08-Apr-2025 - Redlines - DD

4/25/25 DESIGN UPDATE - CW

Lot 46 - Duncans Creek

PLAN 4 The Selma RH 'FARMHOUSE'

OPT. GOURMET KITCHEN
SCALE: 1/8"=1'-0" ON 11x17, 1/4"=1'-0" ON 22x34

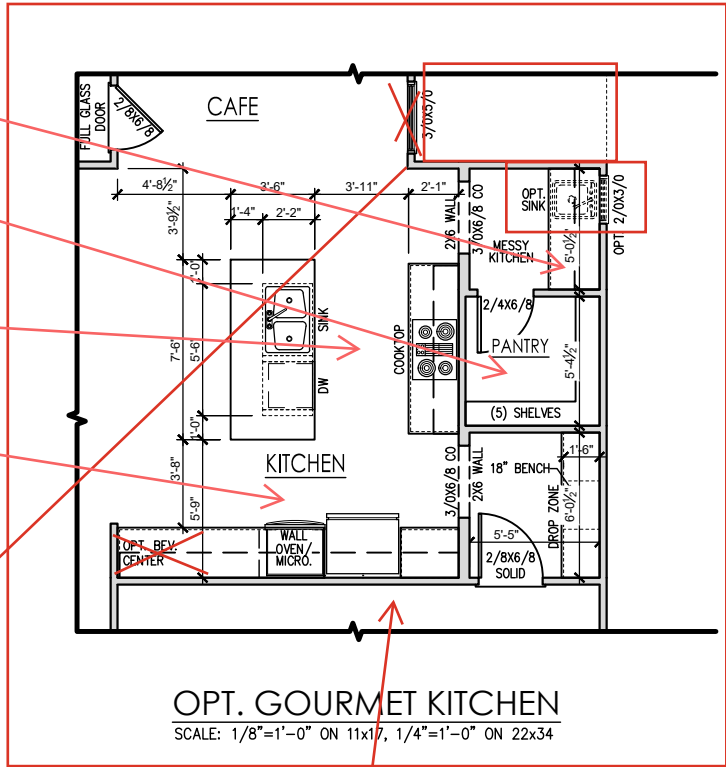
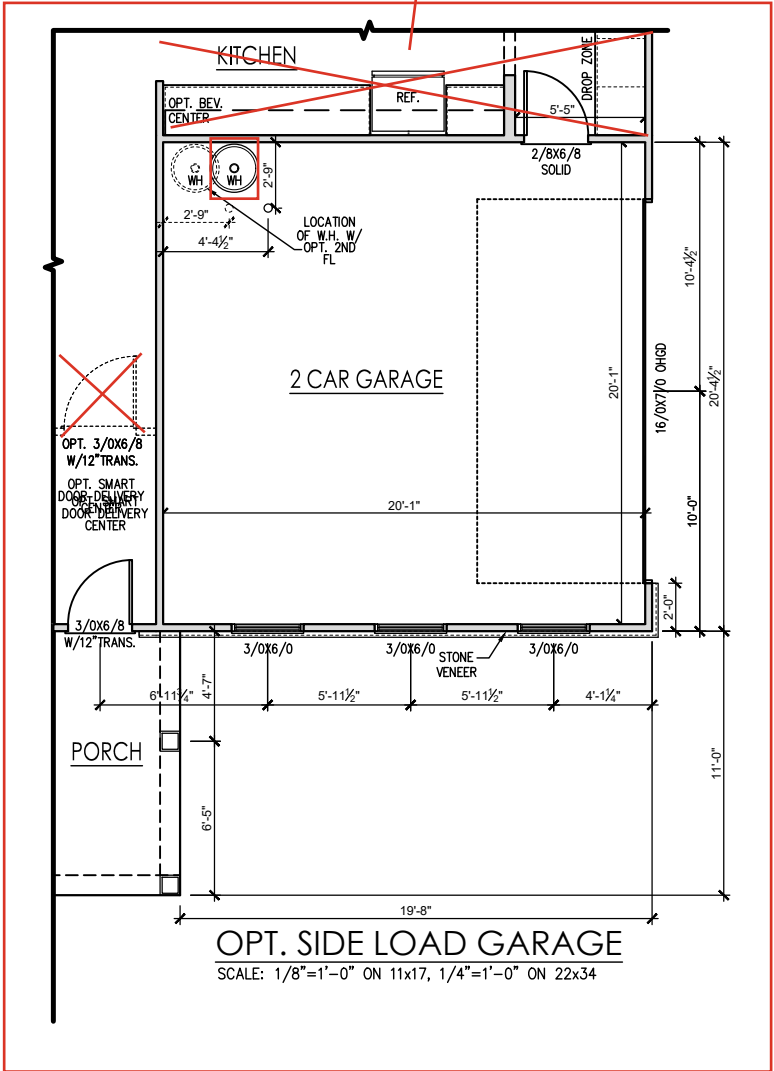
Wine fridge cut out

WOODEN
SHELVING ILO
WIRE
POT FILLER

DOUBLE OVEN
DO NOT INSTALL
MICROWAVE

SECOND FLOOR PLAN 'FARMHOUSE'
SCALE: 1/8"=1'-0" ON 11x17, 1/4"=1'-0" ON 22x34

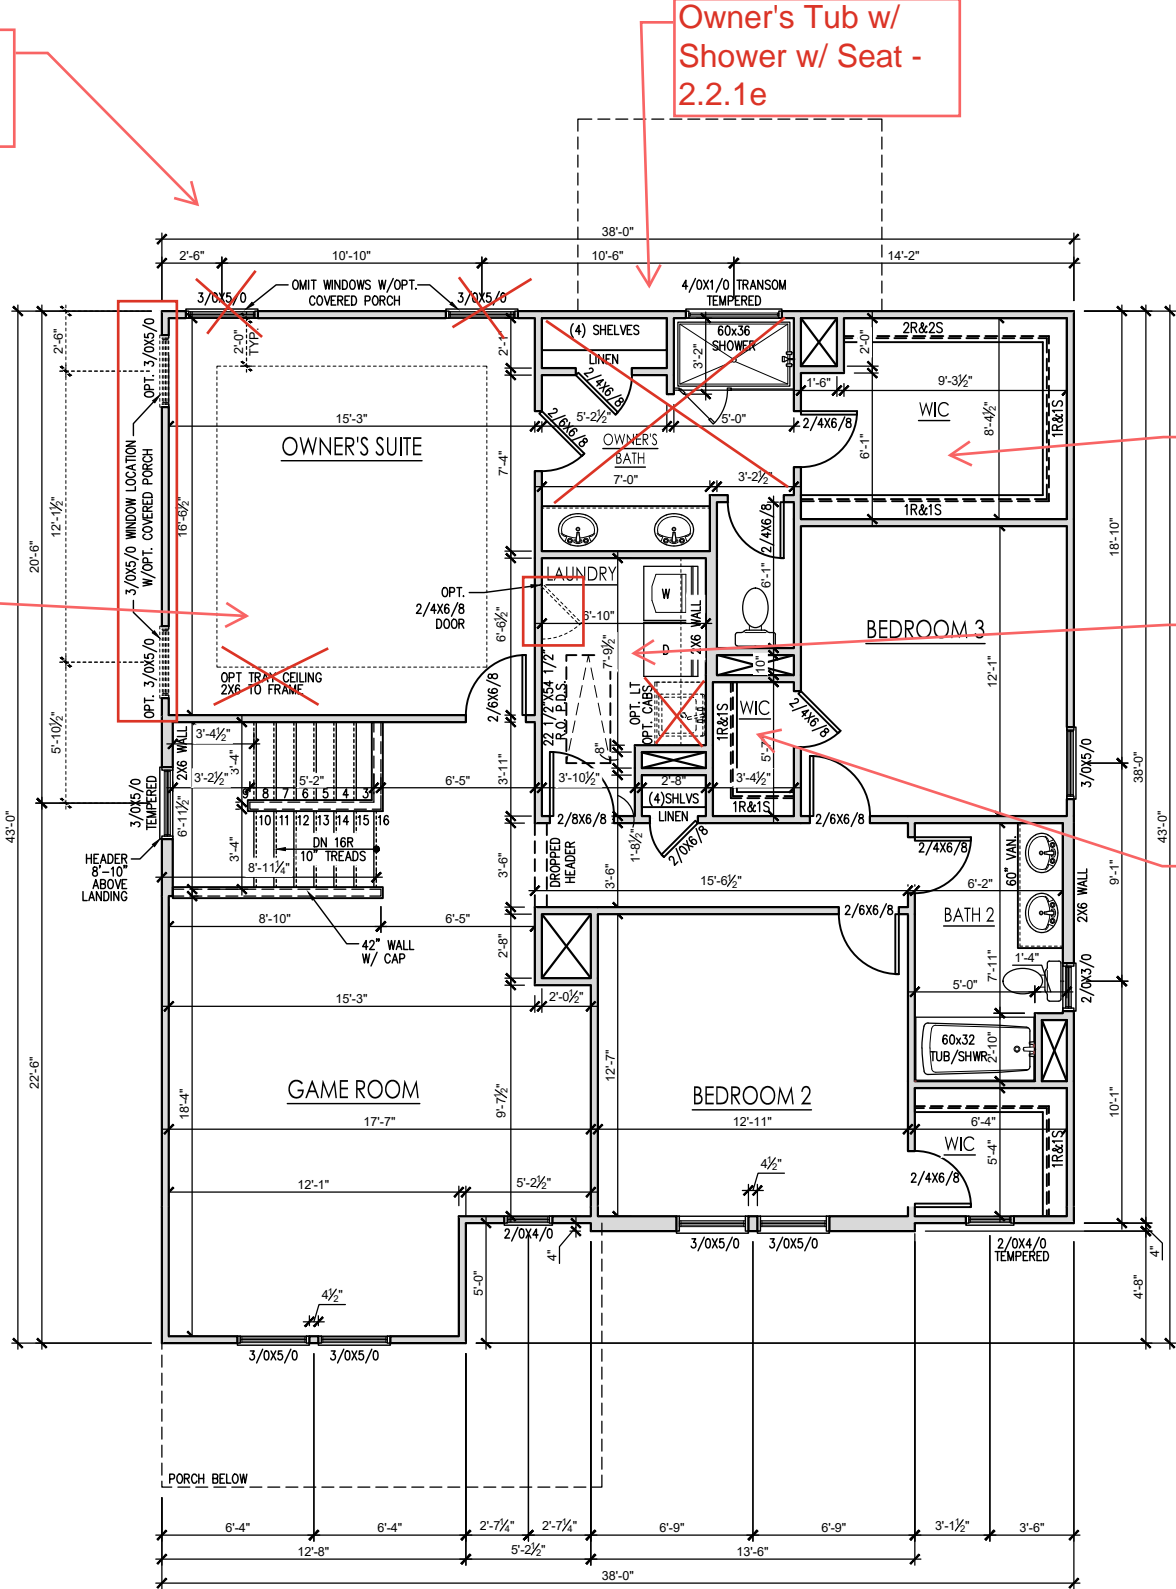
Windows Move Due To Covered Porch

Owner's Tub w/ Shower w/ Seat - 2.2.1e

WOODEN SHELVING ILO WIRE

RAISE LAUNDRY VENT 16" FOR PEDASTAL CLEARANCE

Laundry Counter Next To W/D

NO TRAY

Side Load Garage
- 2.5.1e

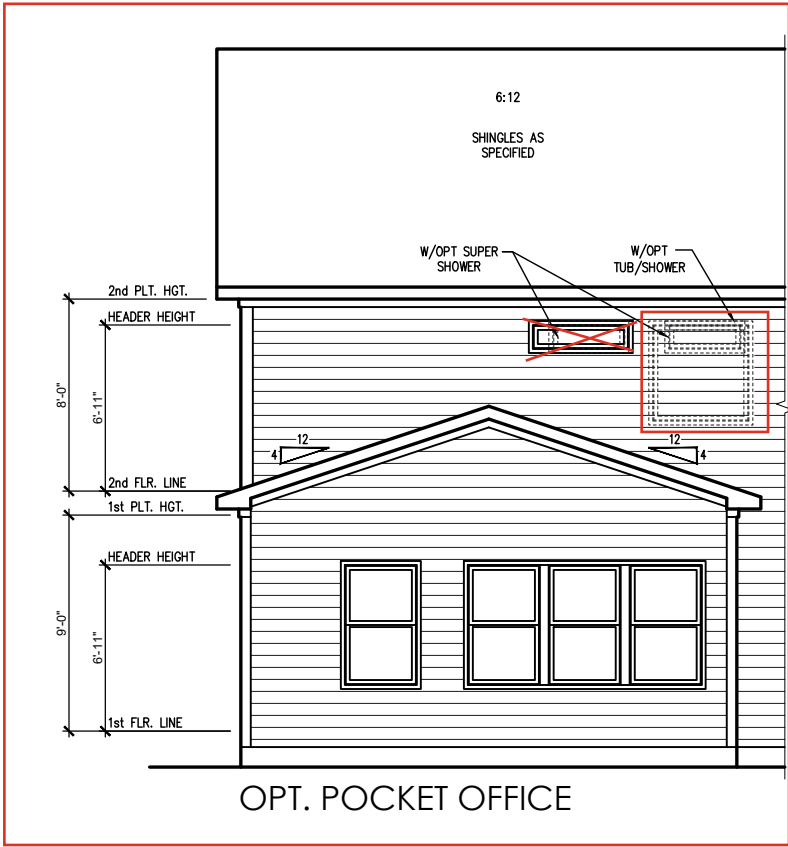
Pocket Office -
3.1.1e

SECOND FLOOR PLAN 'FARMHOUSE'

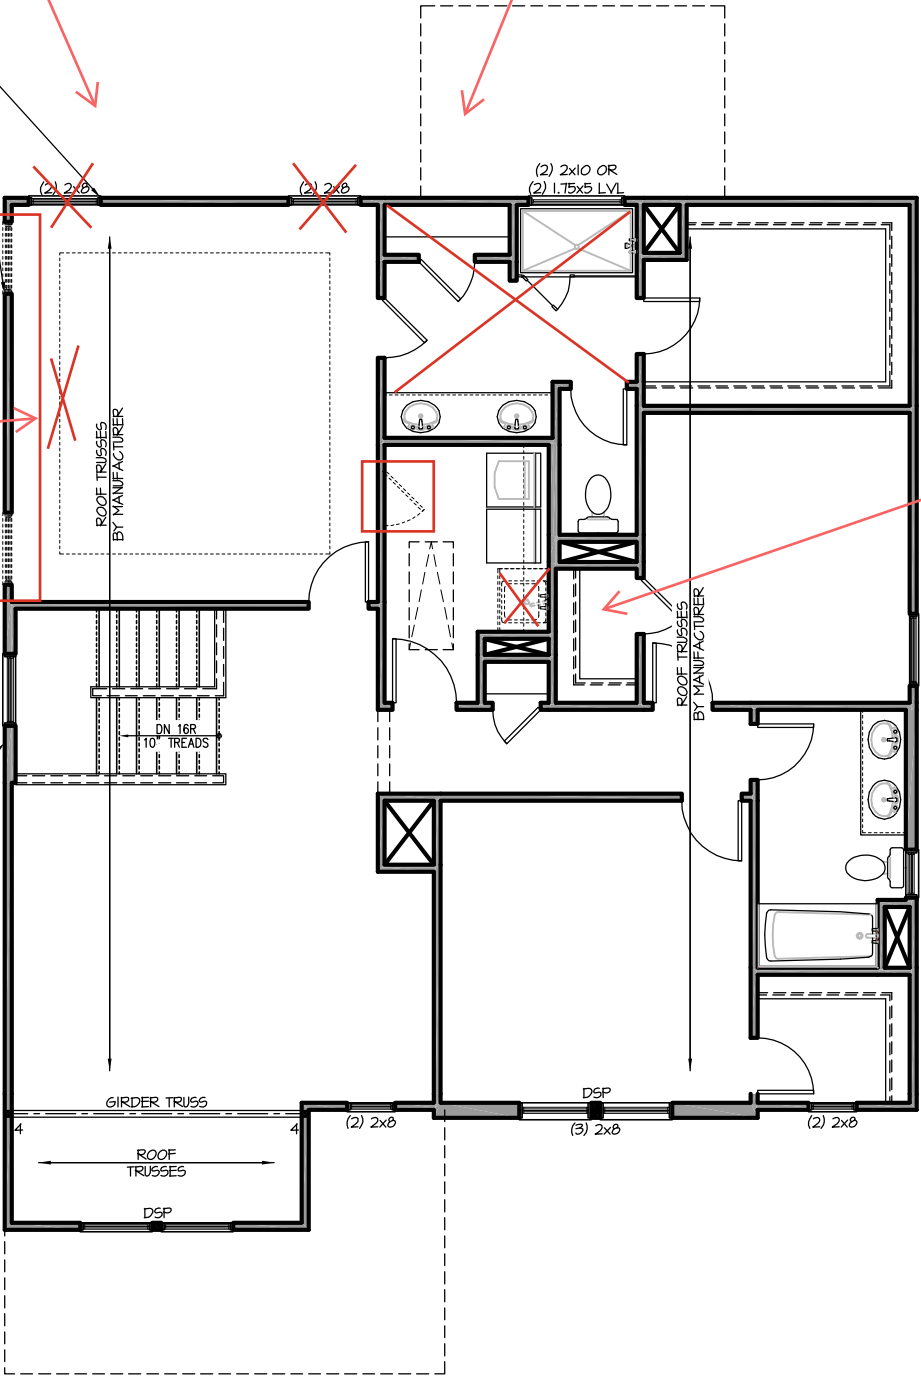
NO TRAY

Windows Move Due To Covered Porch

Owner's Tub w/ Shower w/ Seat - S-2.2.1
